Item ID: D350-689-023 Accept ***N900040100*** Setup Start ***NS1***
 Revision ID: Stop ***NS2***
 Item Name: Energy Attenuating Floor Provisions
 Start Date: 2/04/13 Start Qty: 2.00 *?
 Required Date: 2/04/13 Req'd Qty: 2.00 *?
 Cust Item ID:
 Customer:
 Reference:

DART SERVICE INSTRUCTION

TO AMEND INSTALLATION INSTRUCTIONS IIN-D350-689 REV. B
AND INSTRUCTIONS FOR CONTINUED AIRWORTHINESS ICA-D350-689 REV. 1
REF. TCCA STC: SH02-33
REF. FAA STC: SR01620NY
REF. EASA STC: EASA.IM.R.S.01453
REF. TCA STC: 2005S03-09

FIGURE 1: UPDATES TO CROSS SECTIONS F-F AND M-M
 With reference to Figures 5 and 7 of IIN-D350-689
 (Figures 25-5 and 25-7 of ICA-D350-689)

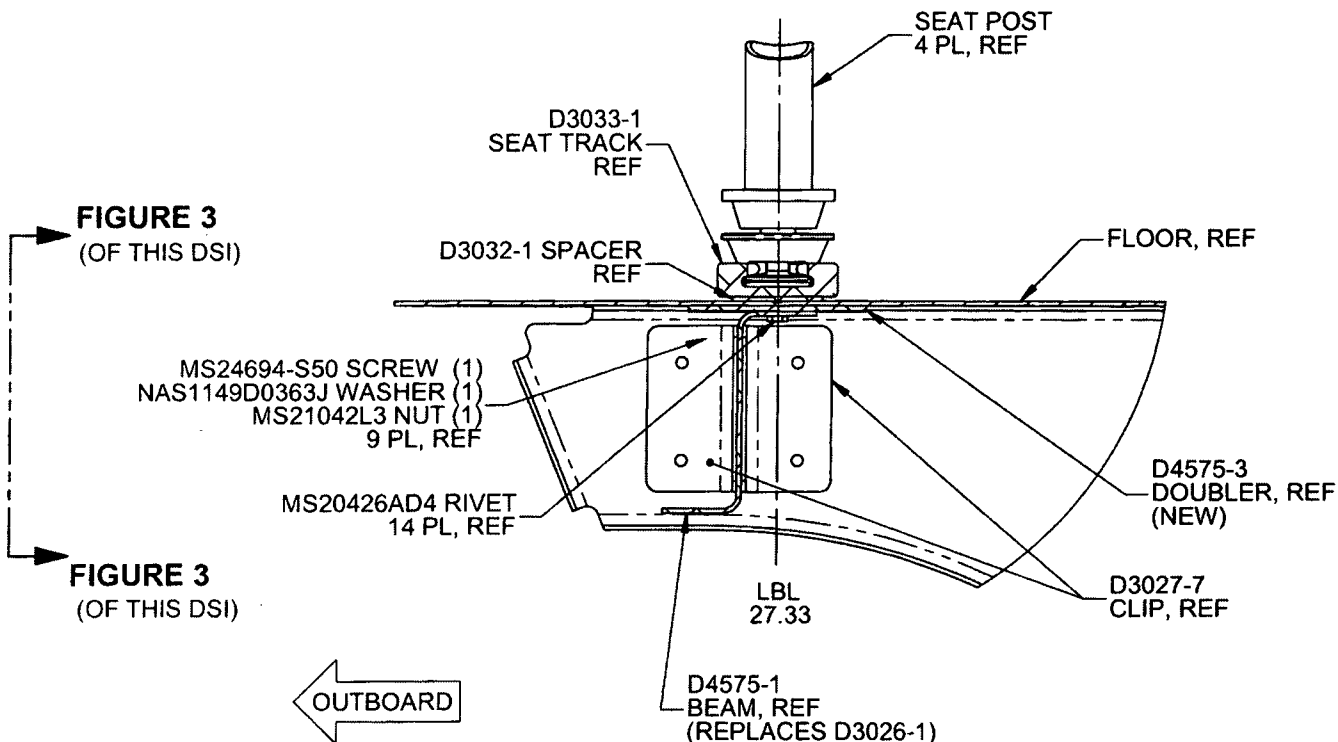
If there is an existing stringer at LBL 27.33, it will need to be removed from that location. Locate D4575-1 Beam, D4575-3 Doubler, and D3032-1 Spacer as shown in Figure 1 of this Service Instruction. Transfer drill existing holes from the aircraft floor to the D4575-1 Beam, D4575-3 Doubler, and D3032-1 Spacer. Ensure 1.0" to 1.5" rivet pitch and add additional holes if required. If there is no existing stringer, locate D4575-1 Beam, D4575-3 Doubler, and D3032-1 Spacer as shown in Figure 1 of this Service Instruction and drill Ø0.128" holes on a 1.0" to 1.5" pitch.

Counter sink holes in the D3032-1 Spacer for MS20426AD4 rivets. Install D4575-1 Beam, D4575-3 Doubler, and D3032-1 Spacer to floor using MS20426AD4 rivets.

FIGURE 2: UPDATES TO FIGURE 21 (IIN-D350-689) AND 25-21 (ICA-D350-689)
 With reference to Figures 19 and 20 of IIN-D350-689
 (Figures 25-19 and 25-20 of ICA-D350-689)

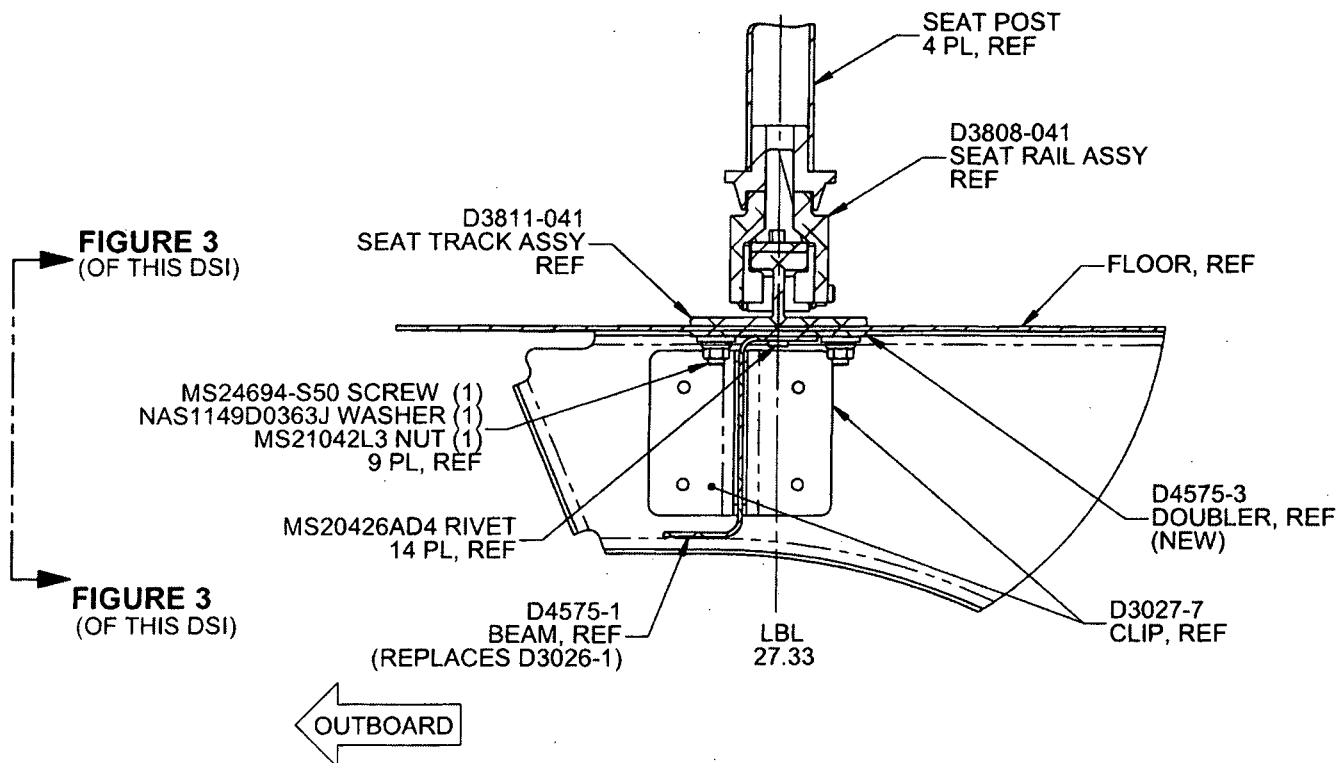
If there is an existing stringer at LBL 27.33, it will need to be removed from that location. Locate D4575-1 Beam and D4575-3 Doubler as shown in Figure 2 of this Service Instruction. Transfer drill existing holes from the aircraft floor to the D4575-1 Beam and D4575-3 Doubler. Ensure 1.0" to 1.5" rivet pitch and add additional holes if required. If there is no existing stringer, locate D4575-1 Beam and D4575-3 Doubler as shown in Figure 1 of this Service Instruction and drill Ø0.128" holes on a 1.0" to 1.5" pitch.

Attach D4575-1 Beam and D4575-3 Doubler to floor using qty (14) MS20426AD4 rivets.

FIGURE 3: RELIEFS ON D4575-1/-3
(ONLY D4575-1/-3 SHOWN FOR CLARITY)
VIEW LOOKING INBOARD

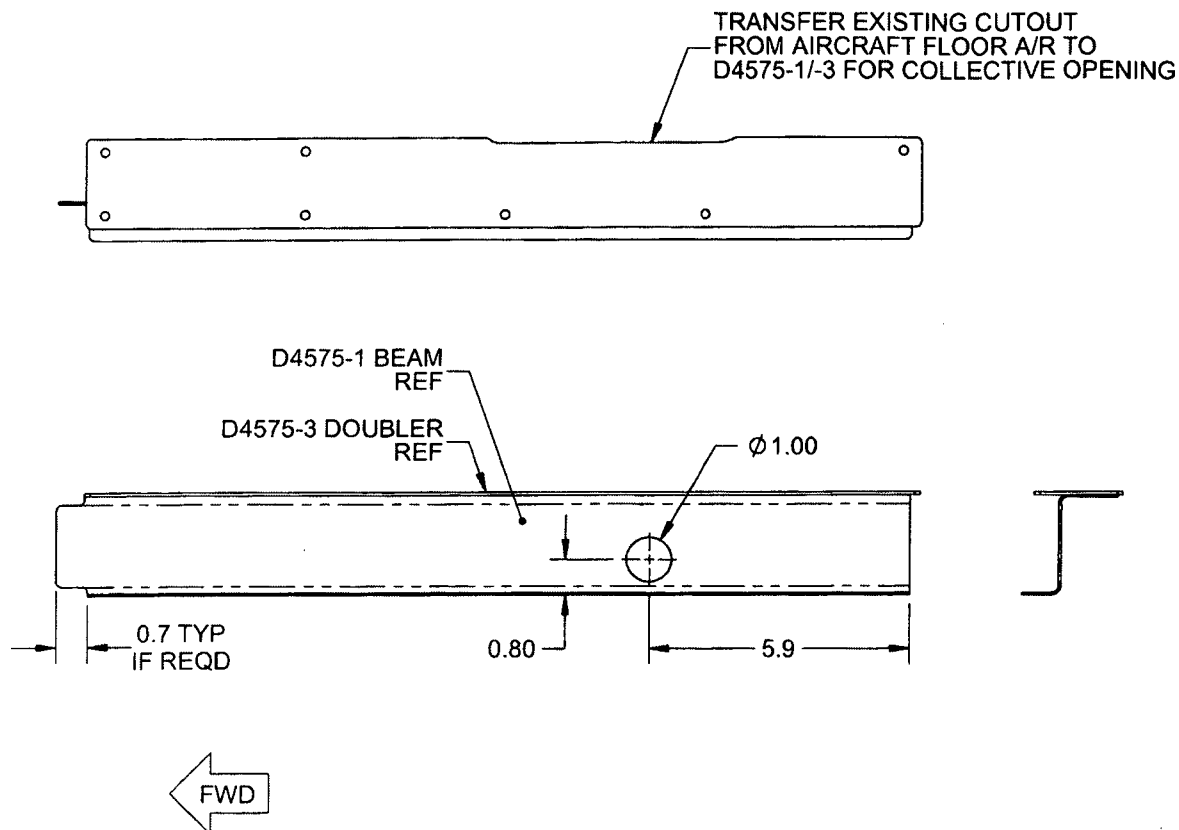
Note: Drill a Ø1.00" (Ø25.4 mm) hole in the D4575-1 Beam to clear extension tube of collective and cutout as required for clearance of collective opening and fwd bulkhead as shown in Figure 3 of this Service Instruction.

Note: Drill a Ø1.00" (Ø25.4 mm) hole in the D4575-1 Beam to clear extension tube of collective and cutout as required for clearance of collective opening and fwd bulkhead as shown in Figure 3 of this Service Instruction.
